RE: **Winrock Road Town Center**
2100 Louisiana Blvd NE
Drainage Master Plan- Drainage Implementation Plan
Engineer's Stamp Date: 5/16/19
Hydrology File: J19D058

Based on submittal received on 5/17/19, the Drainage Implementation Plan cannot be approved for Site Plan for Building Permit until the following are corrected:

RE: Winrock Town Center Drainage Implementation Plan
Hydrology File: J19D058

WINROCK TOWN CENTER DRAINAGE IMPLEMENTATION PLAN

WINROCK TOWN CENTER PHASE B INFRASTRUCTURE IMPROVEMENTS			
TITLE: STORM DRAIN AP-B 200 & 201			
Design Review Committee	City Engineer	Ms./Day/Yr.	
		Last Update	
City Project No.	Zone Map No.	Sheet	Of
4553.90	J-19-Z		EXHIBIT 3

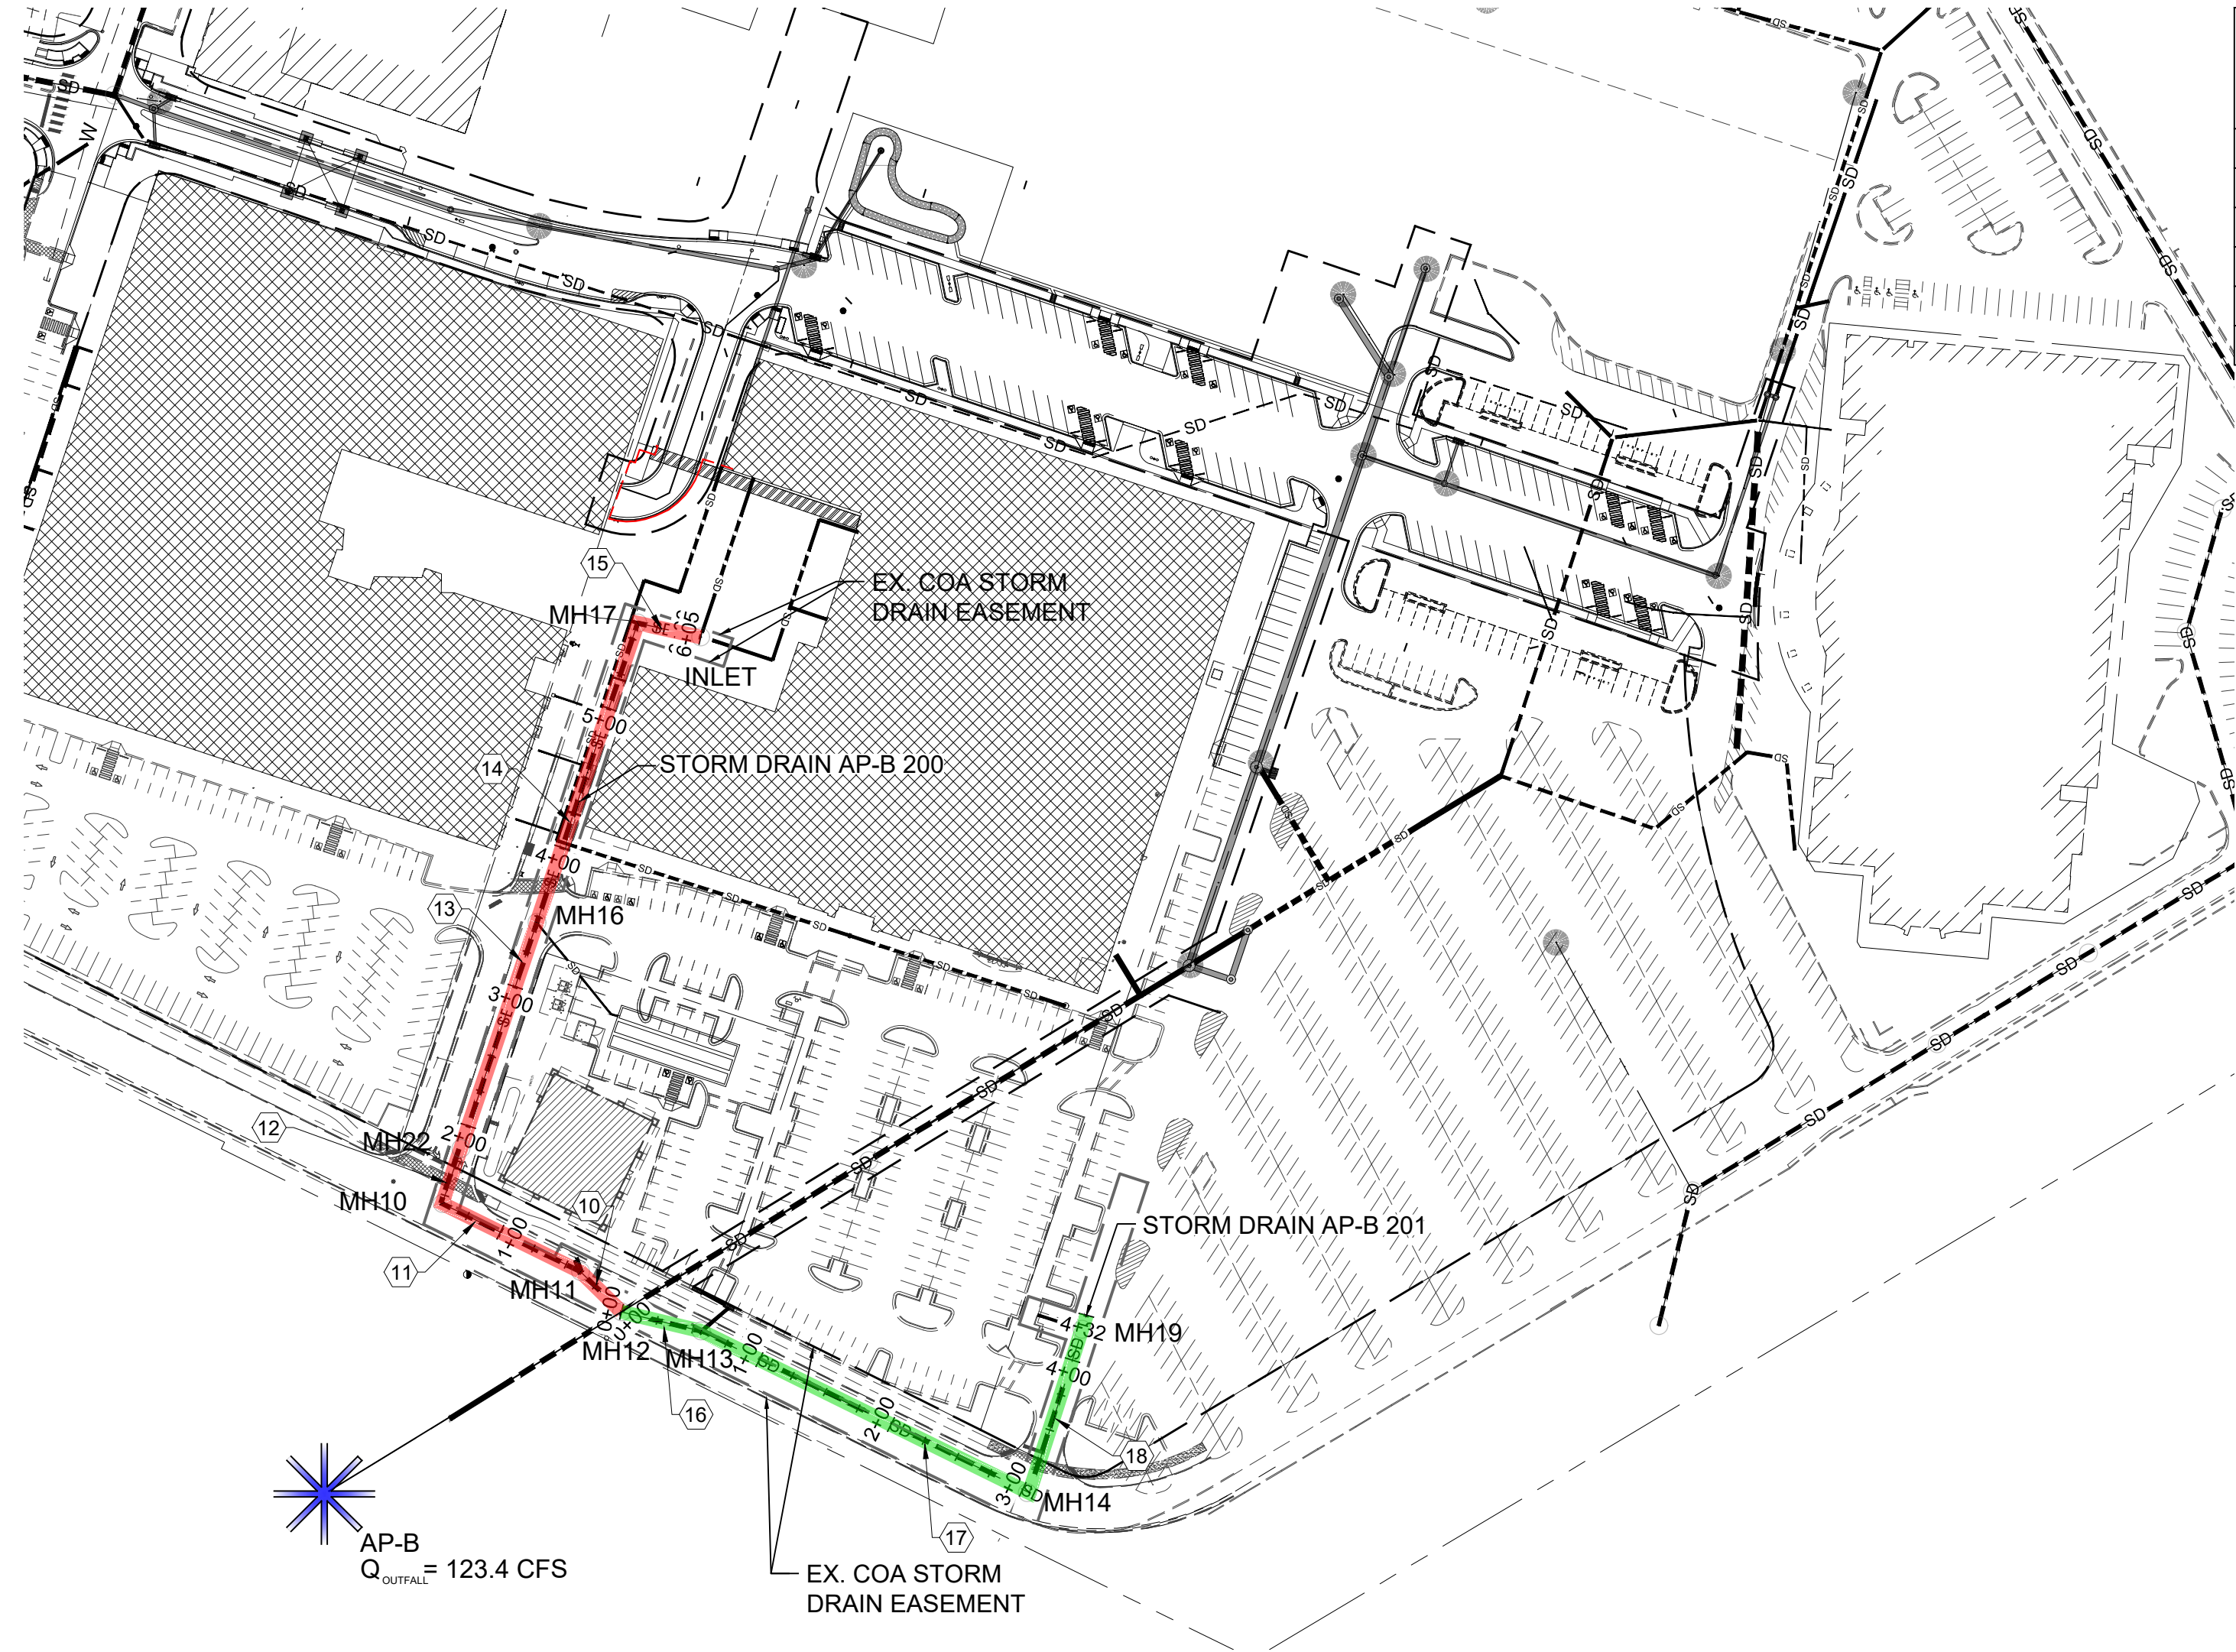
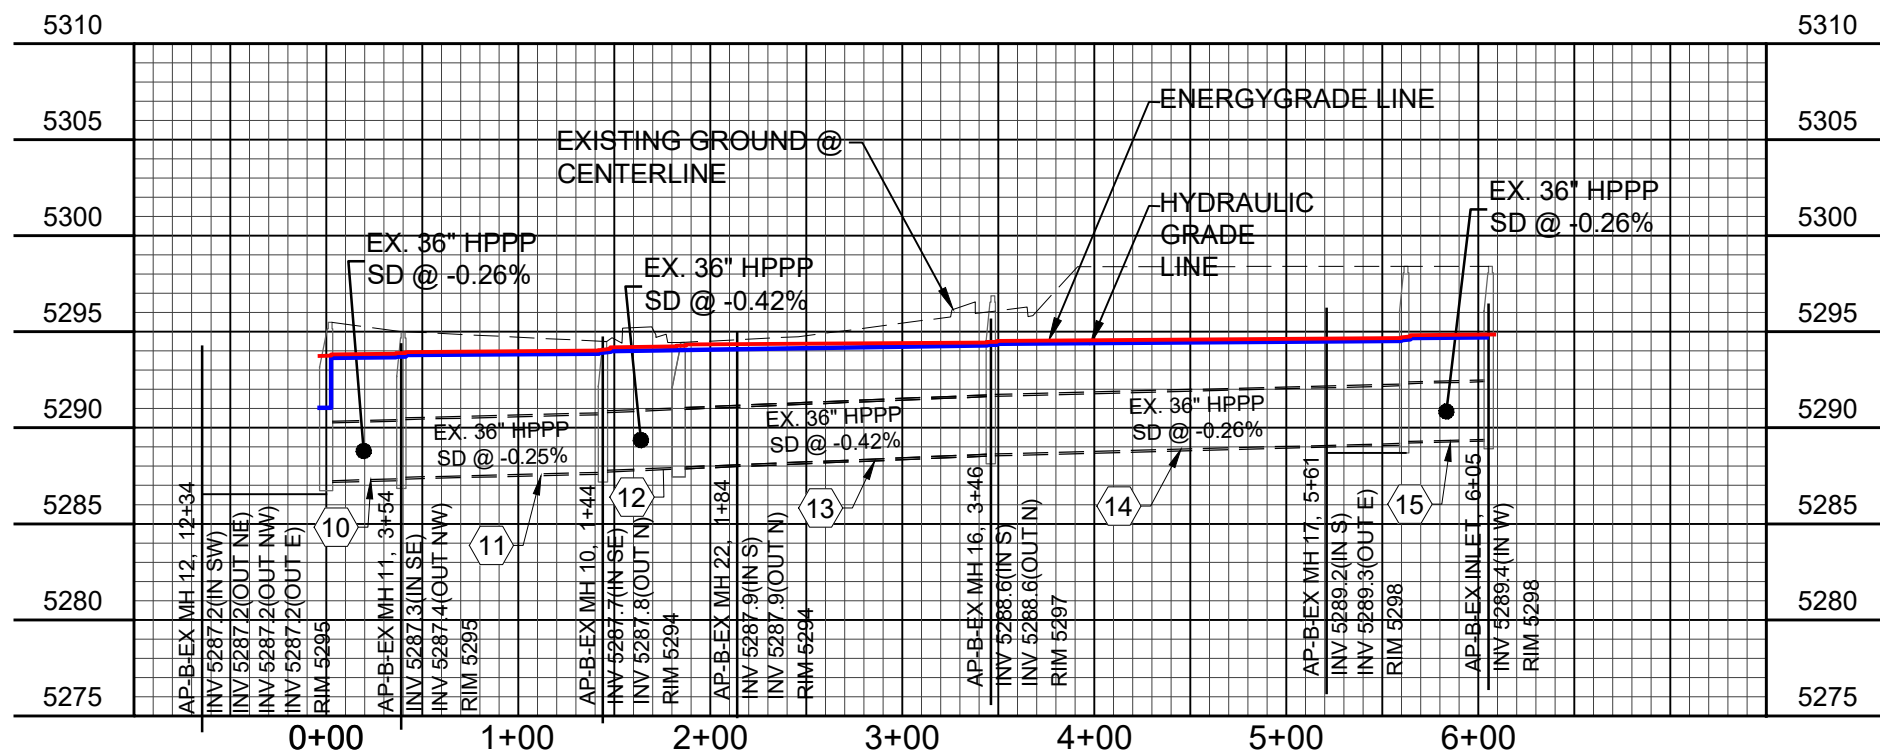
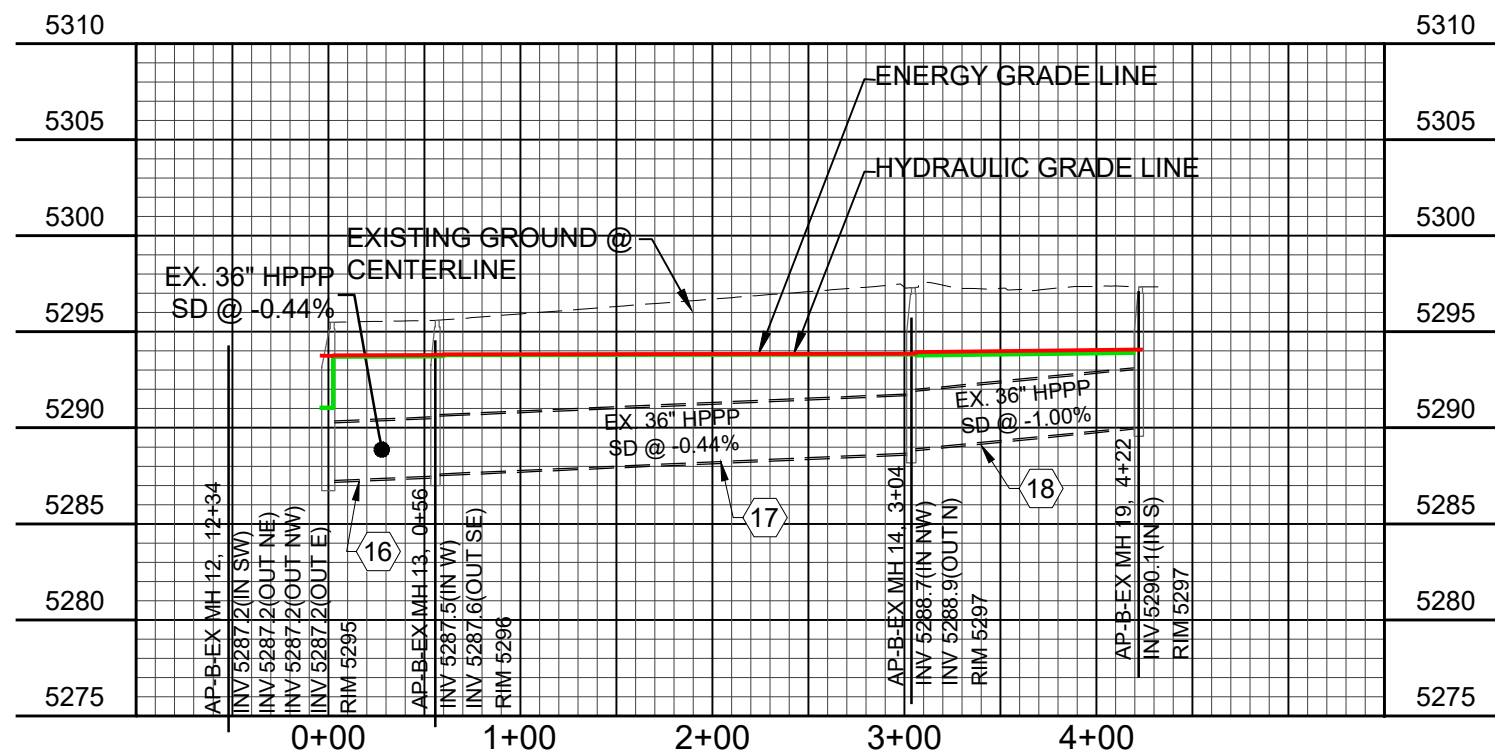
- c. On Exhibit 3,
 - i. pipe 12 is called out as 36" in profile, but is 24" in the table;
 - ii. pipe 18 is called out as 36" in profile, but is 24" in the table;

- iii. pipe 16 Q is 14.3cfs, but is shown as 22cfs on the exhibit 1 table.
 - d. On Exhibit 4,
 - i. pipe 6 is called out as 48" in profile and on the exhibit 1 table, but is 36" in the table;
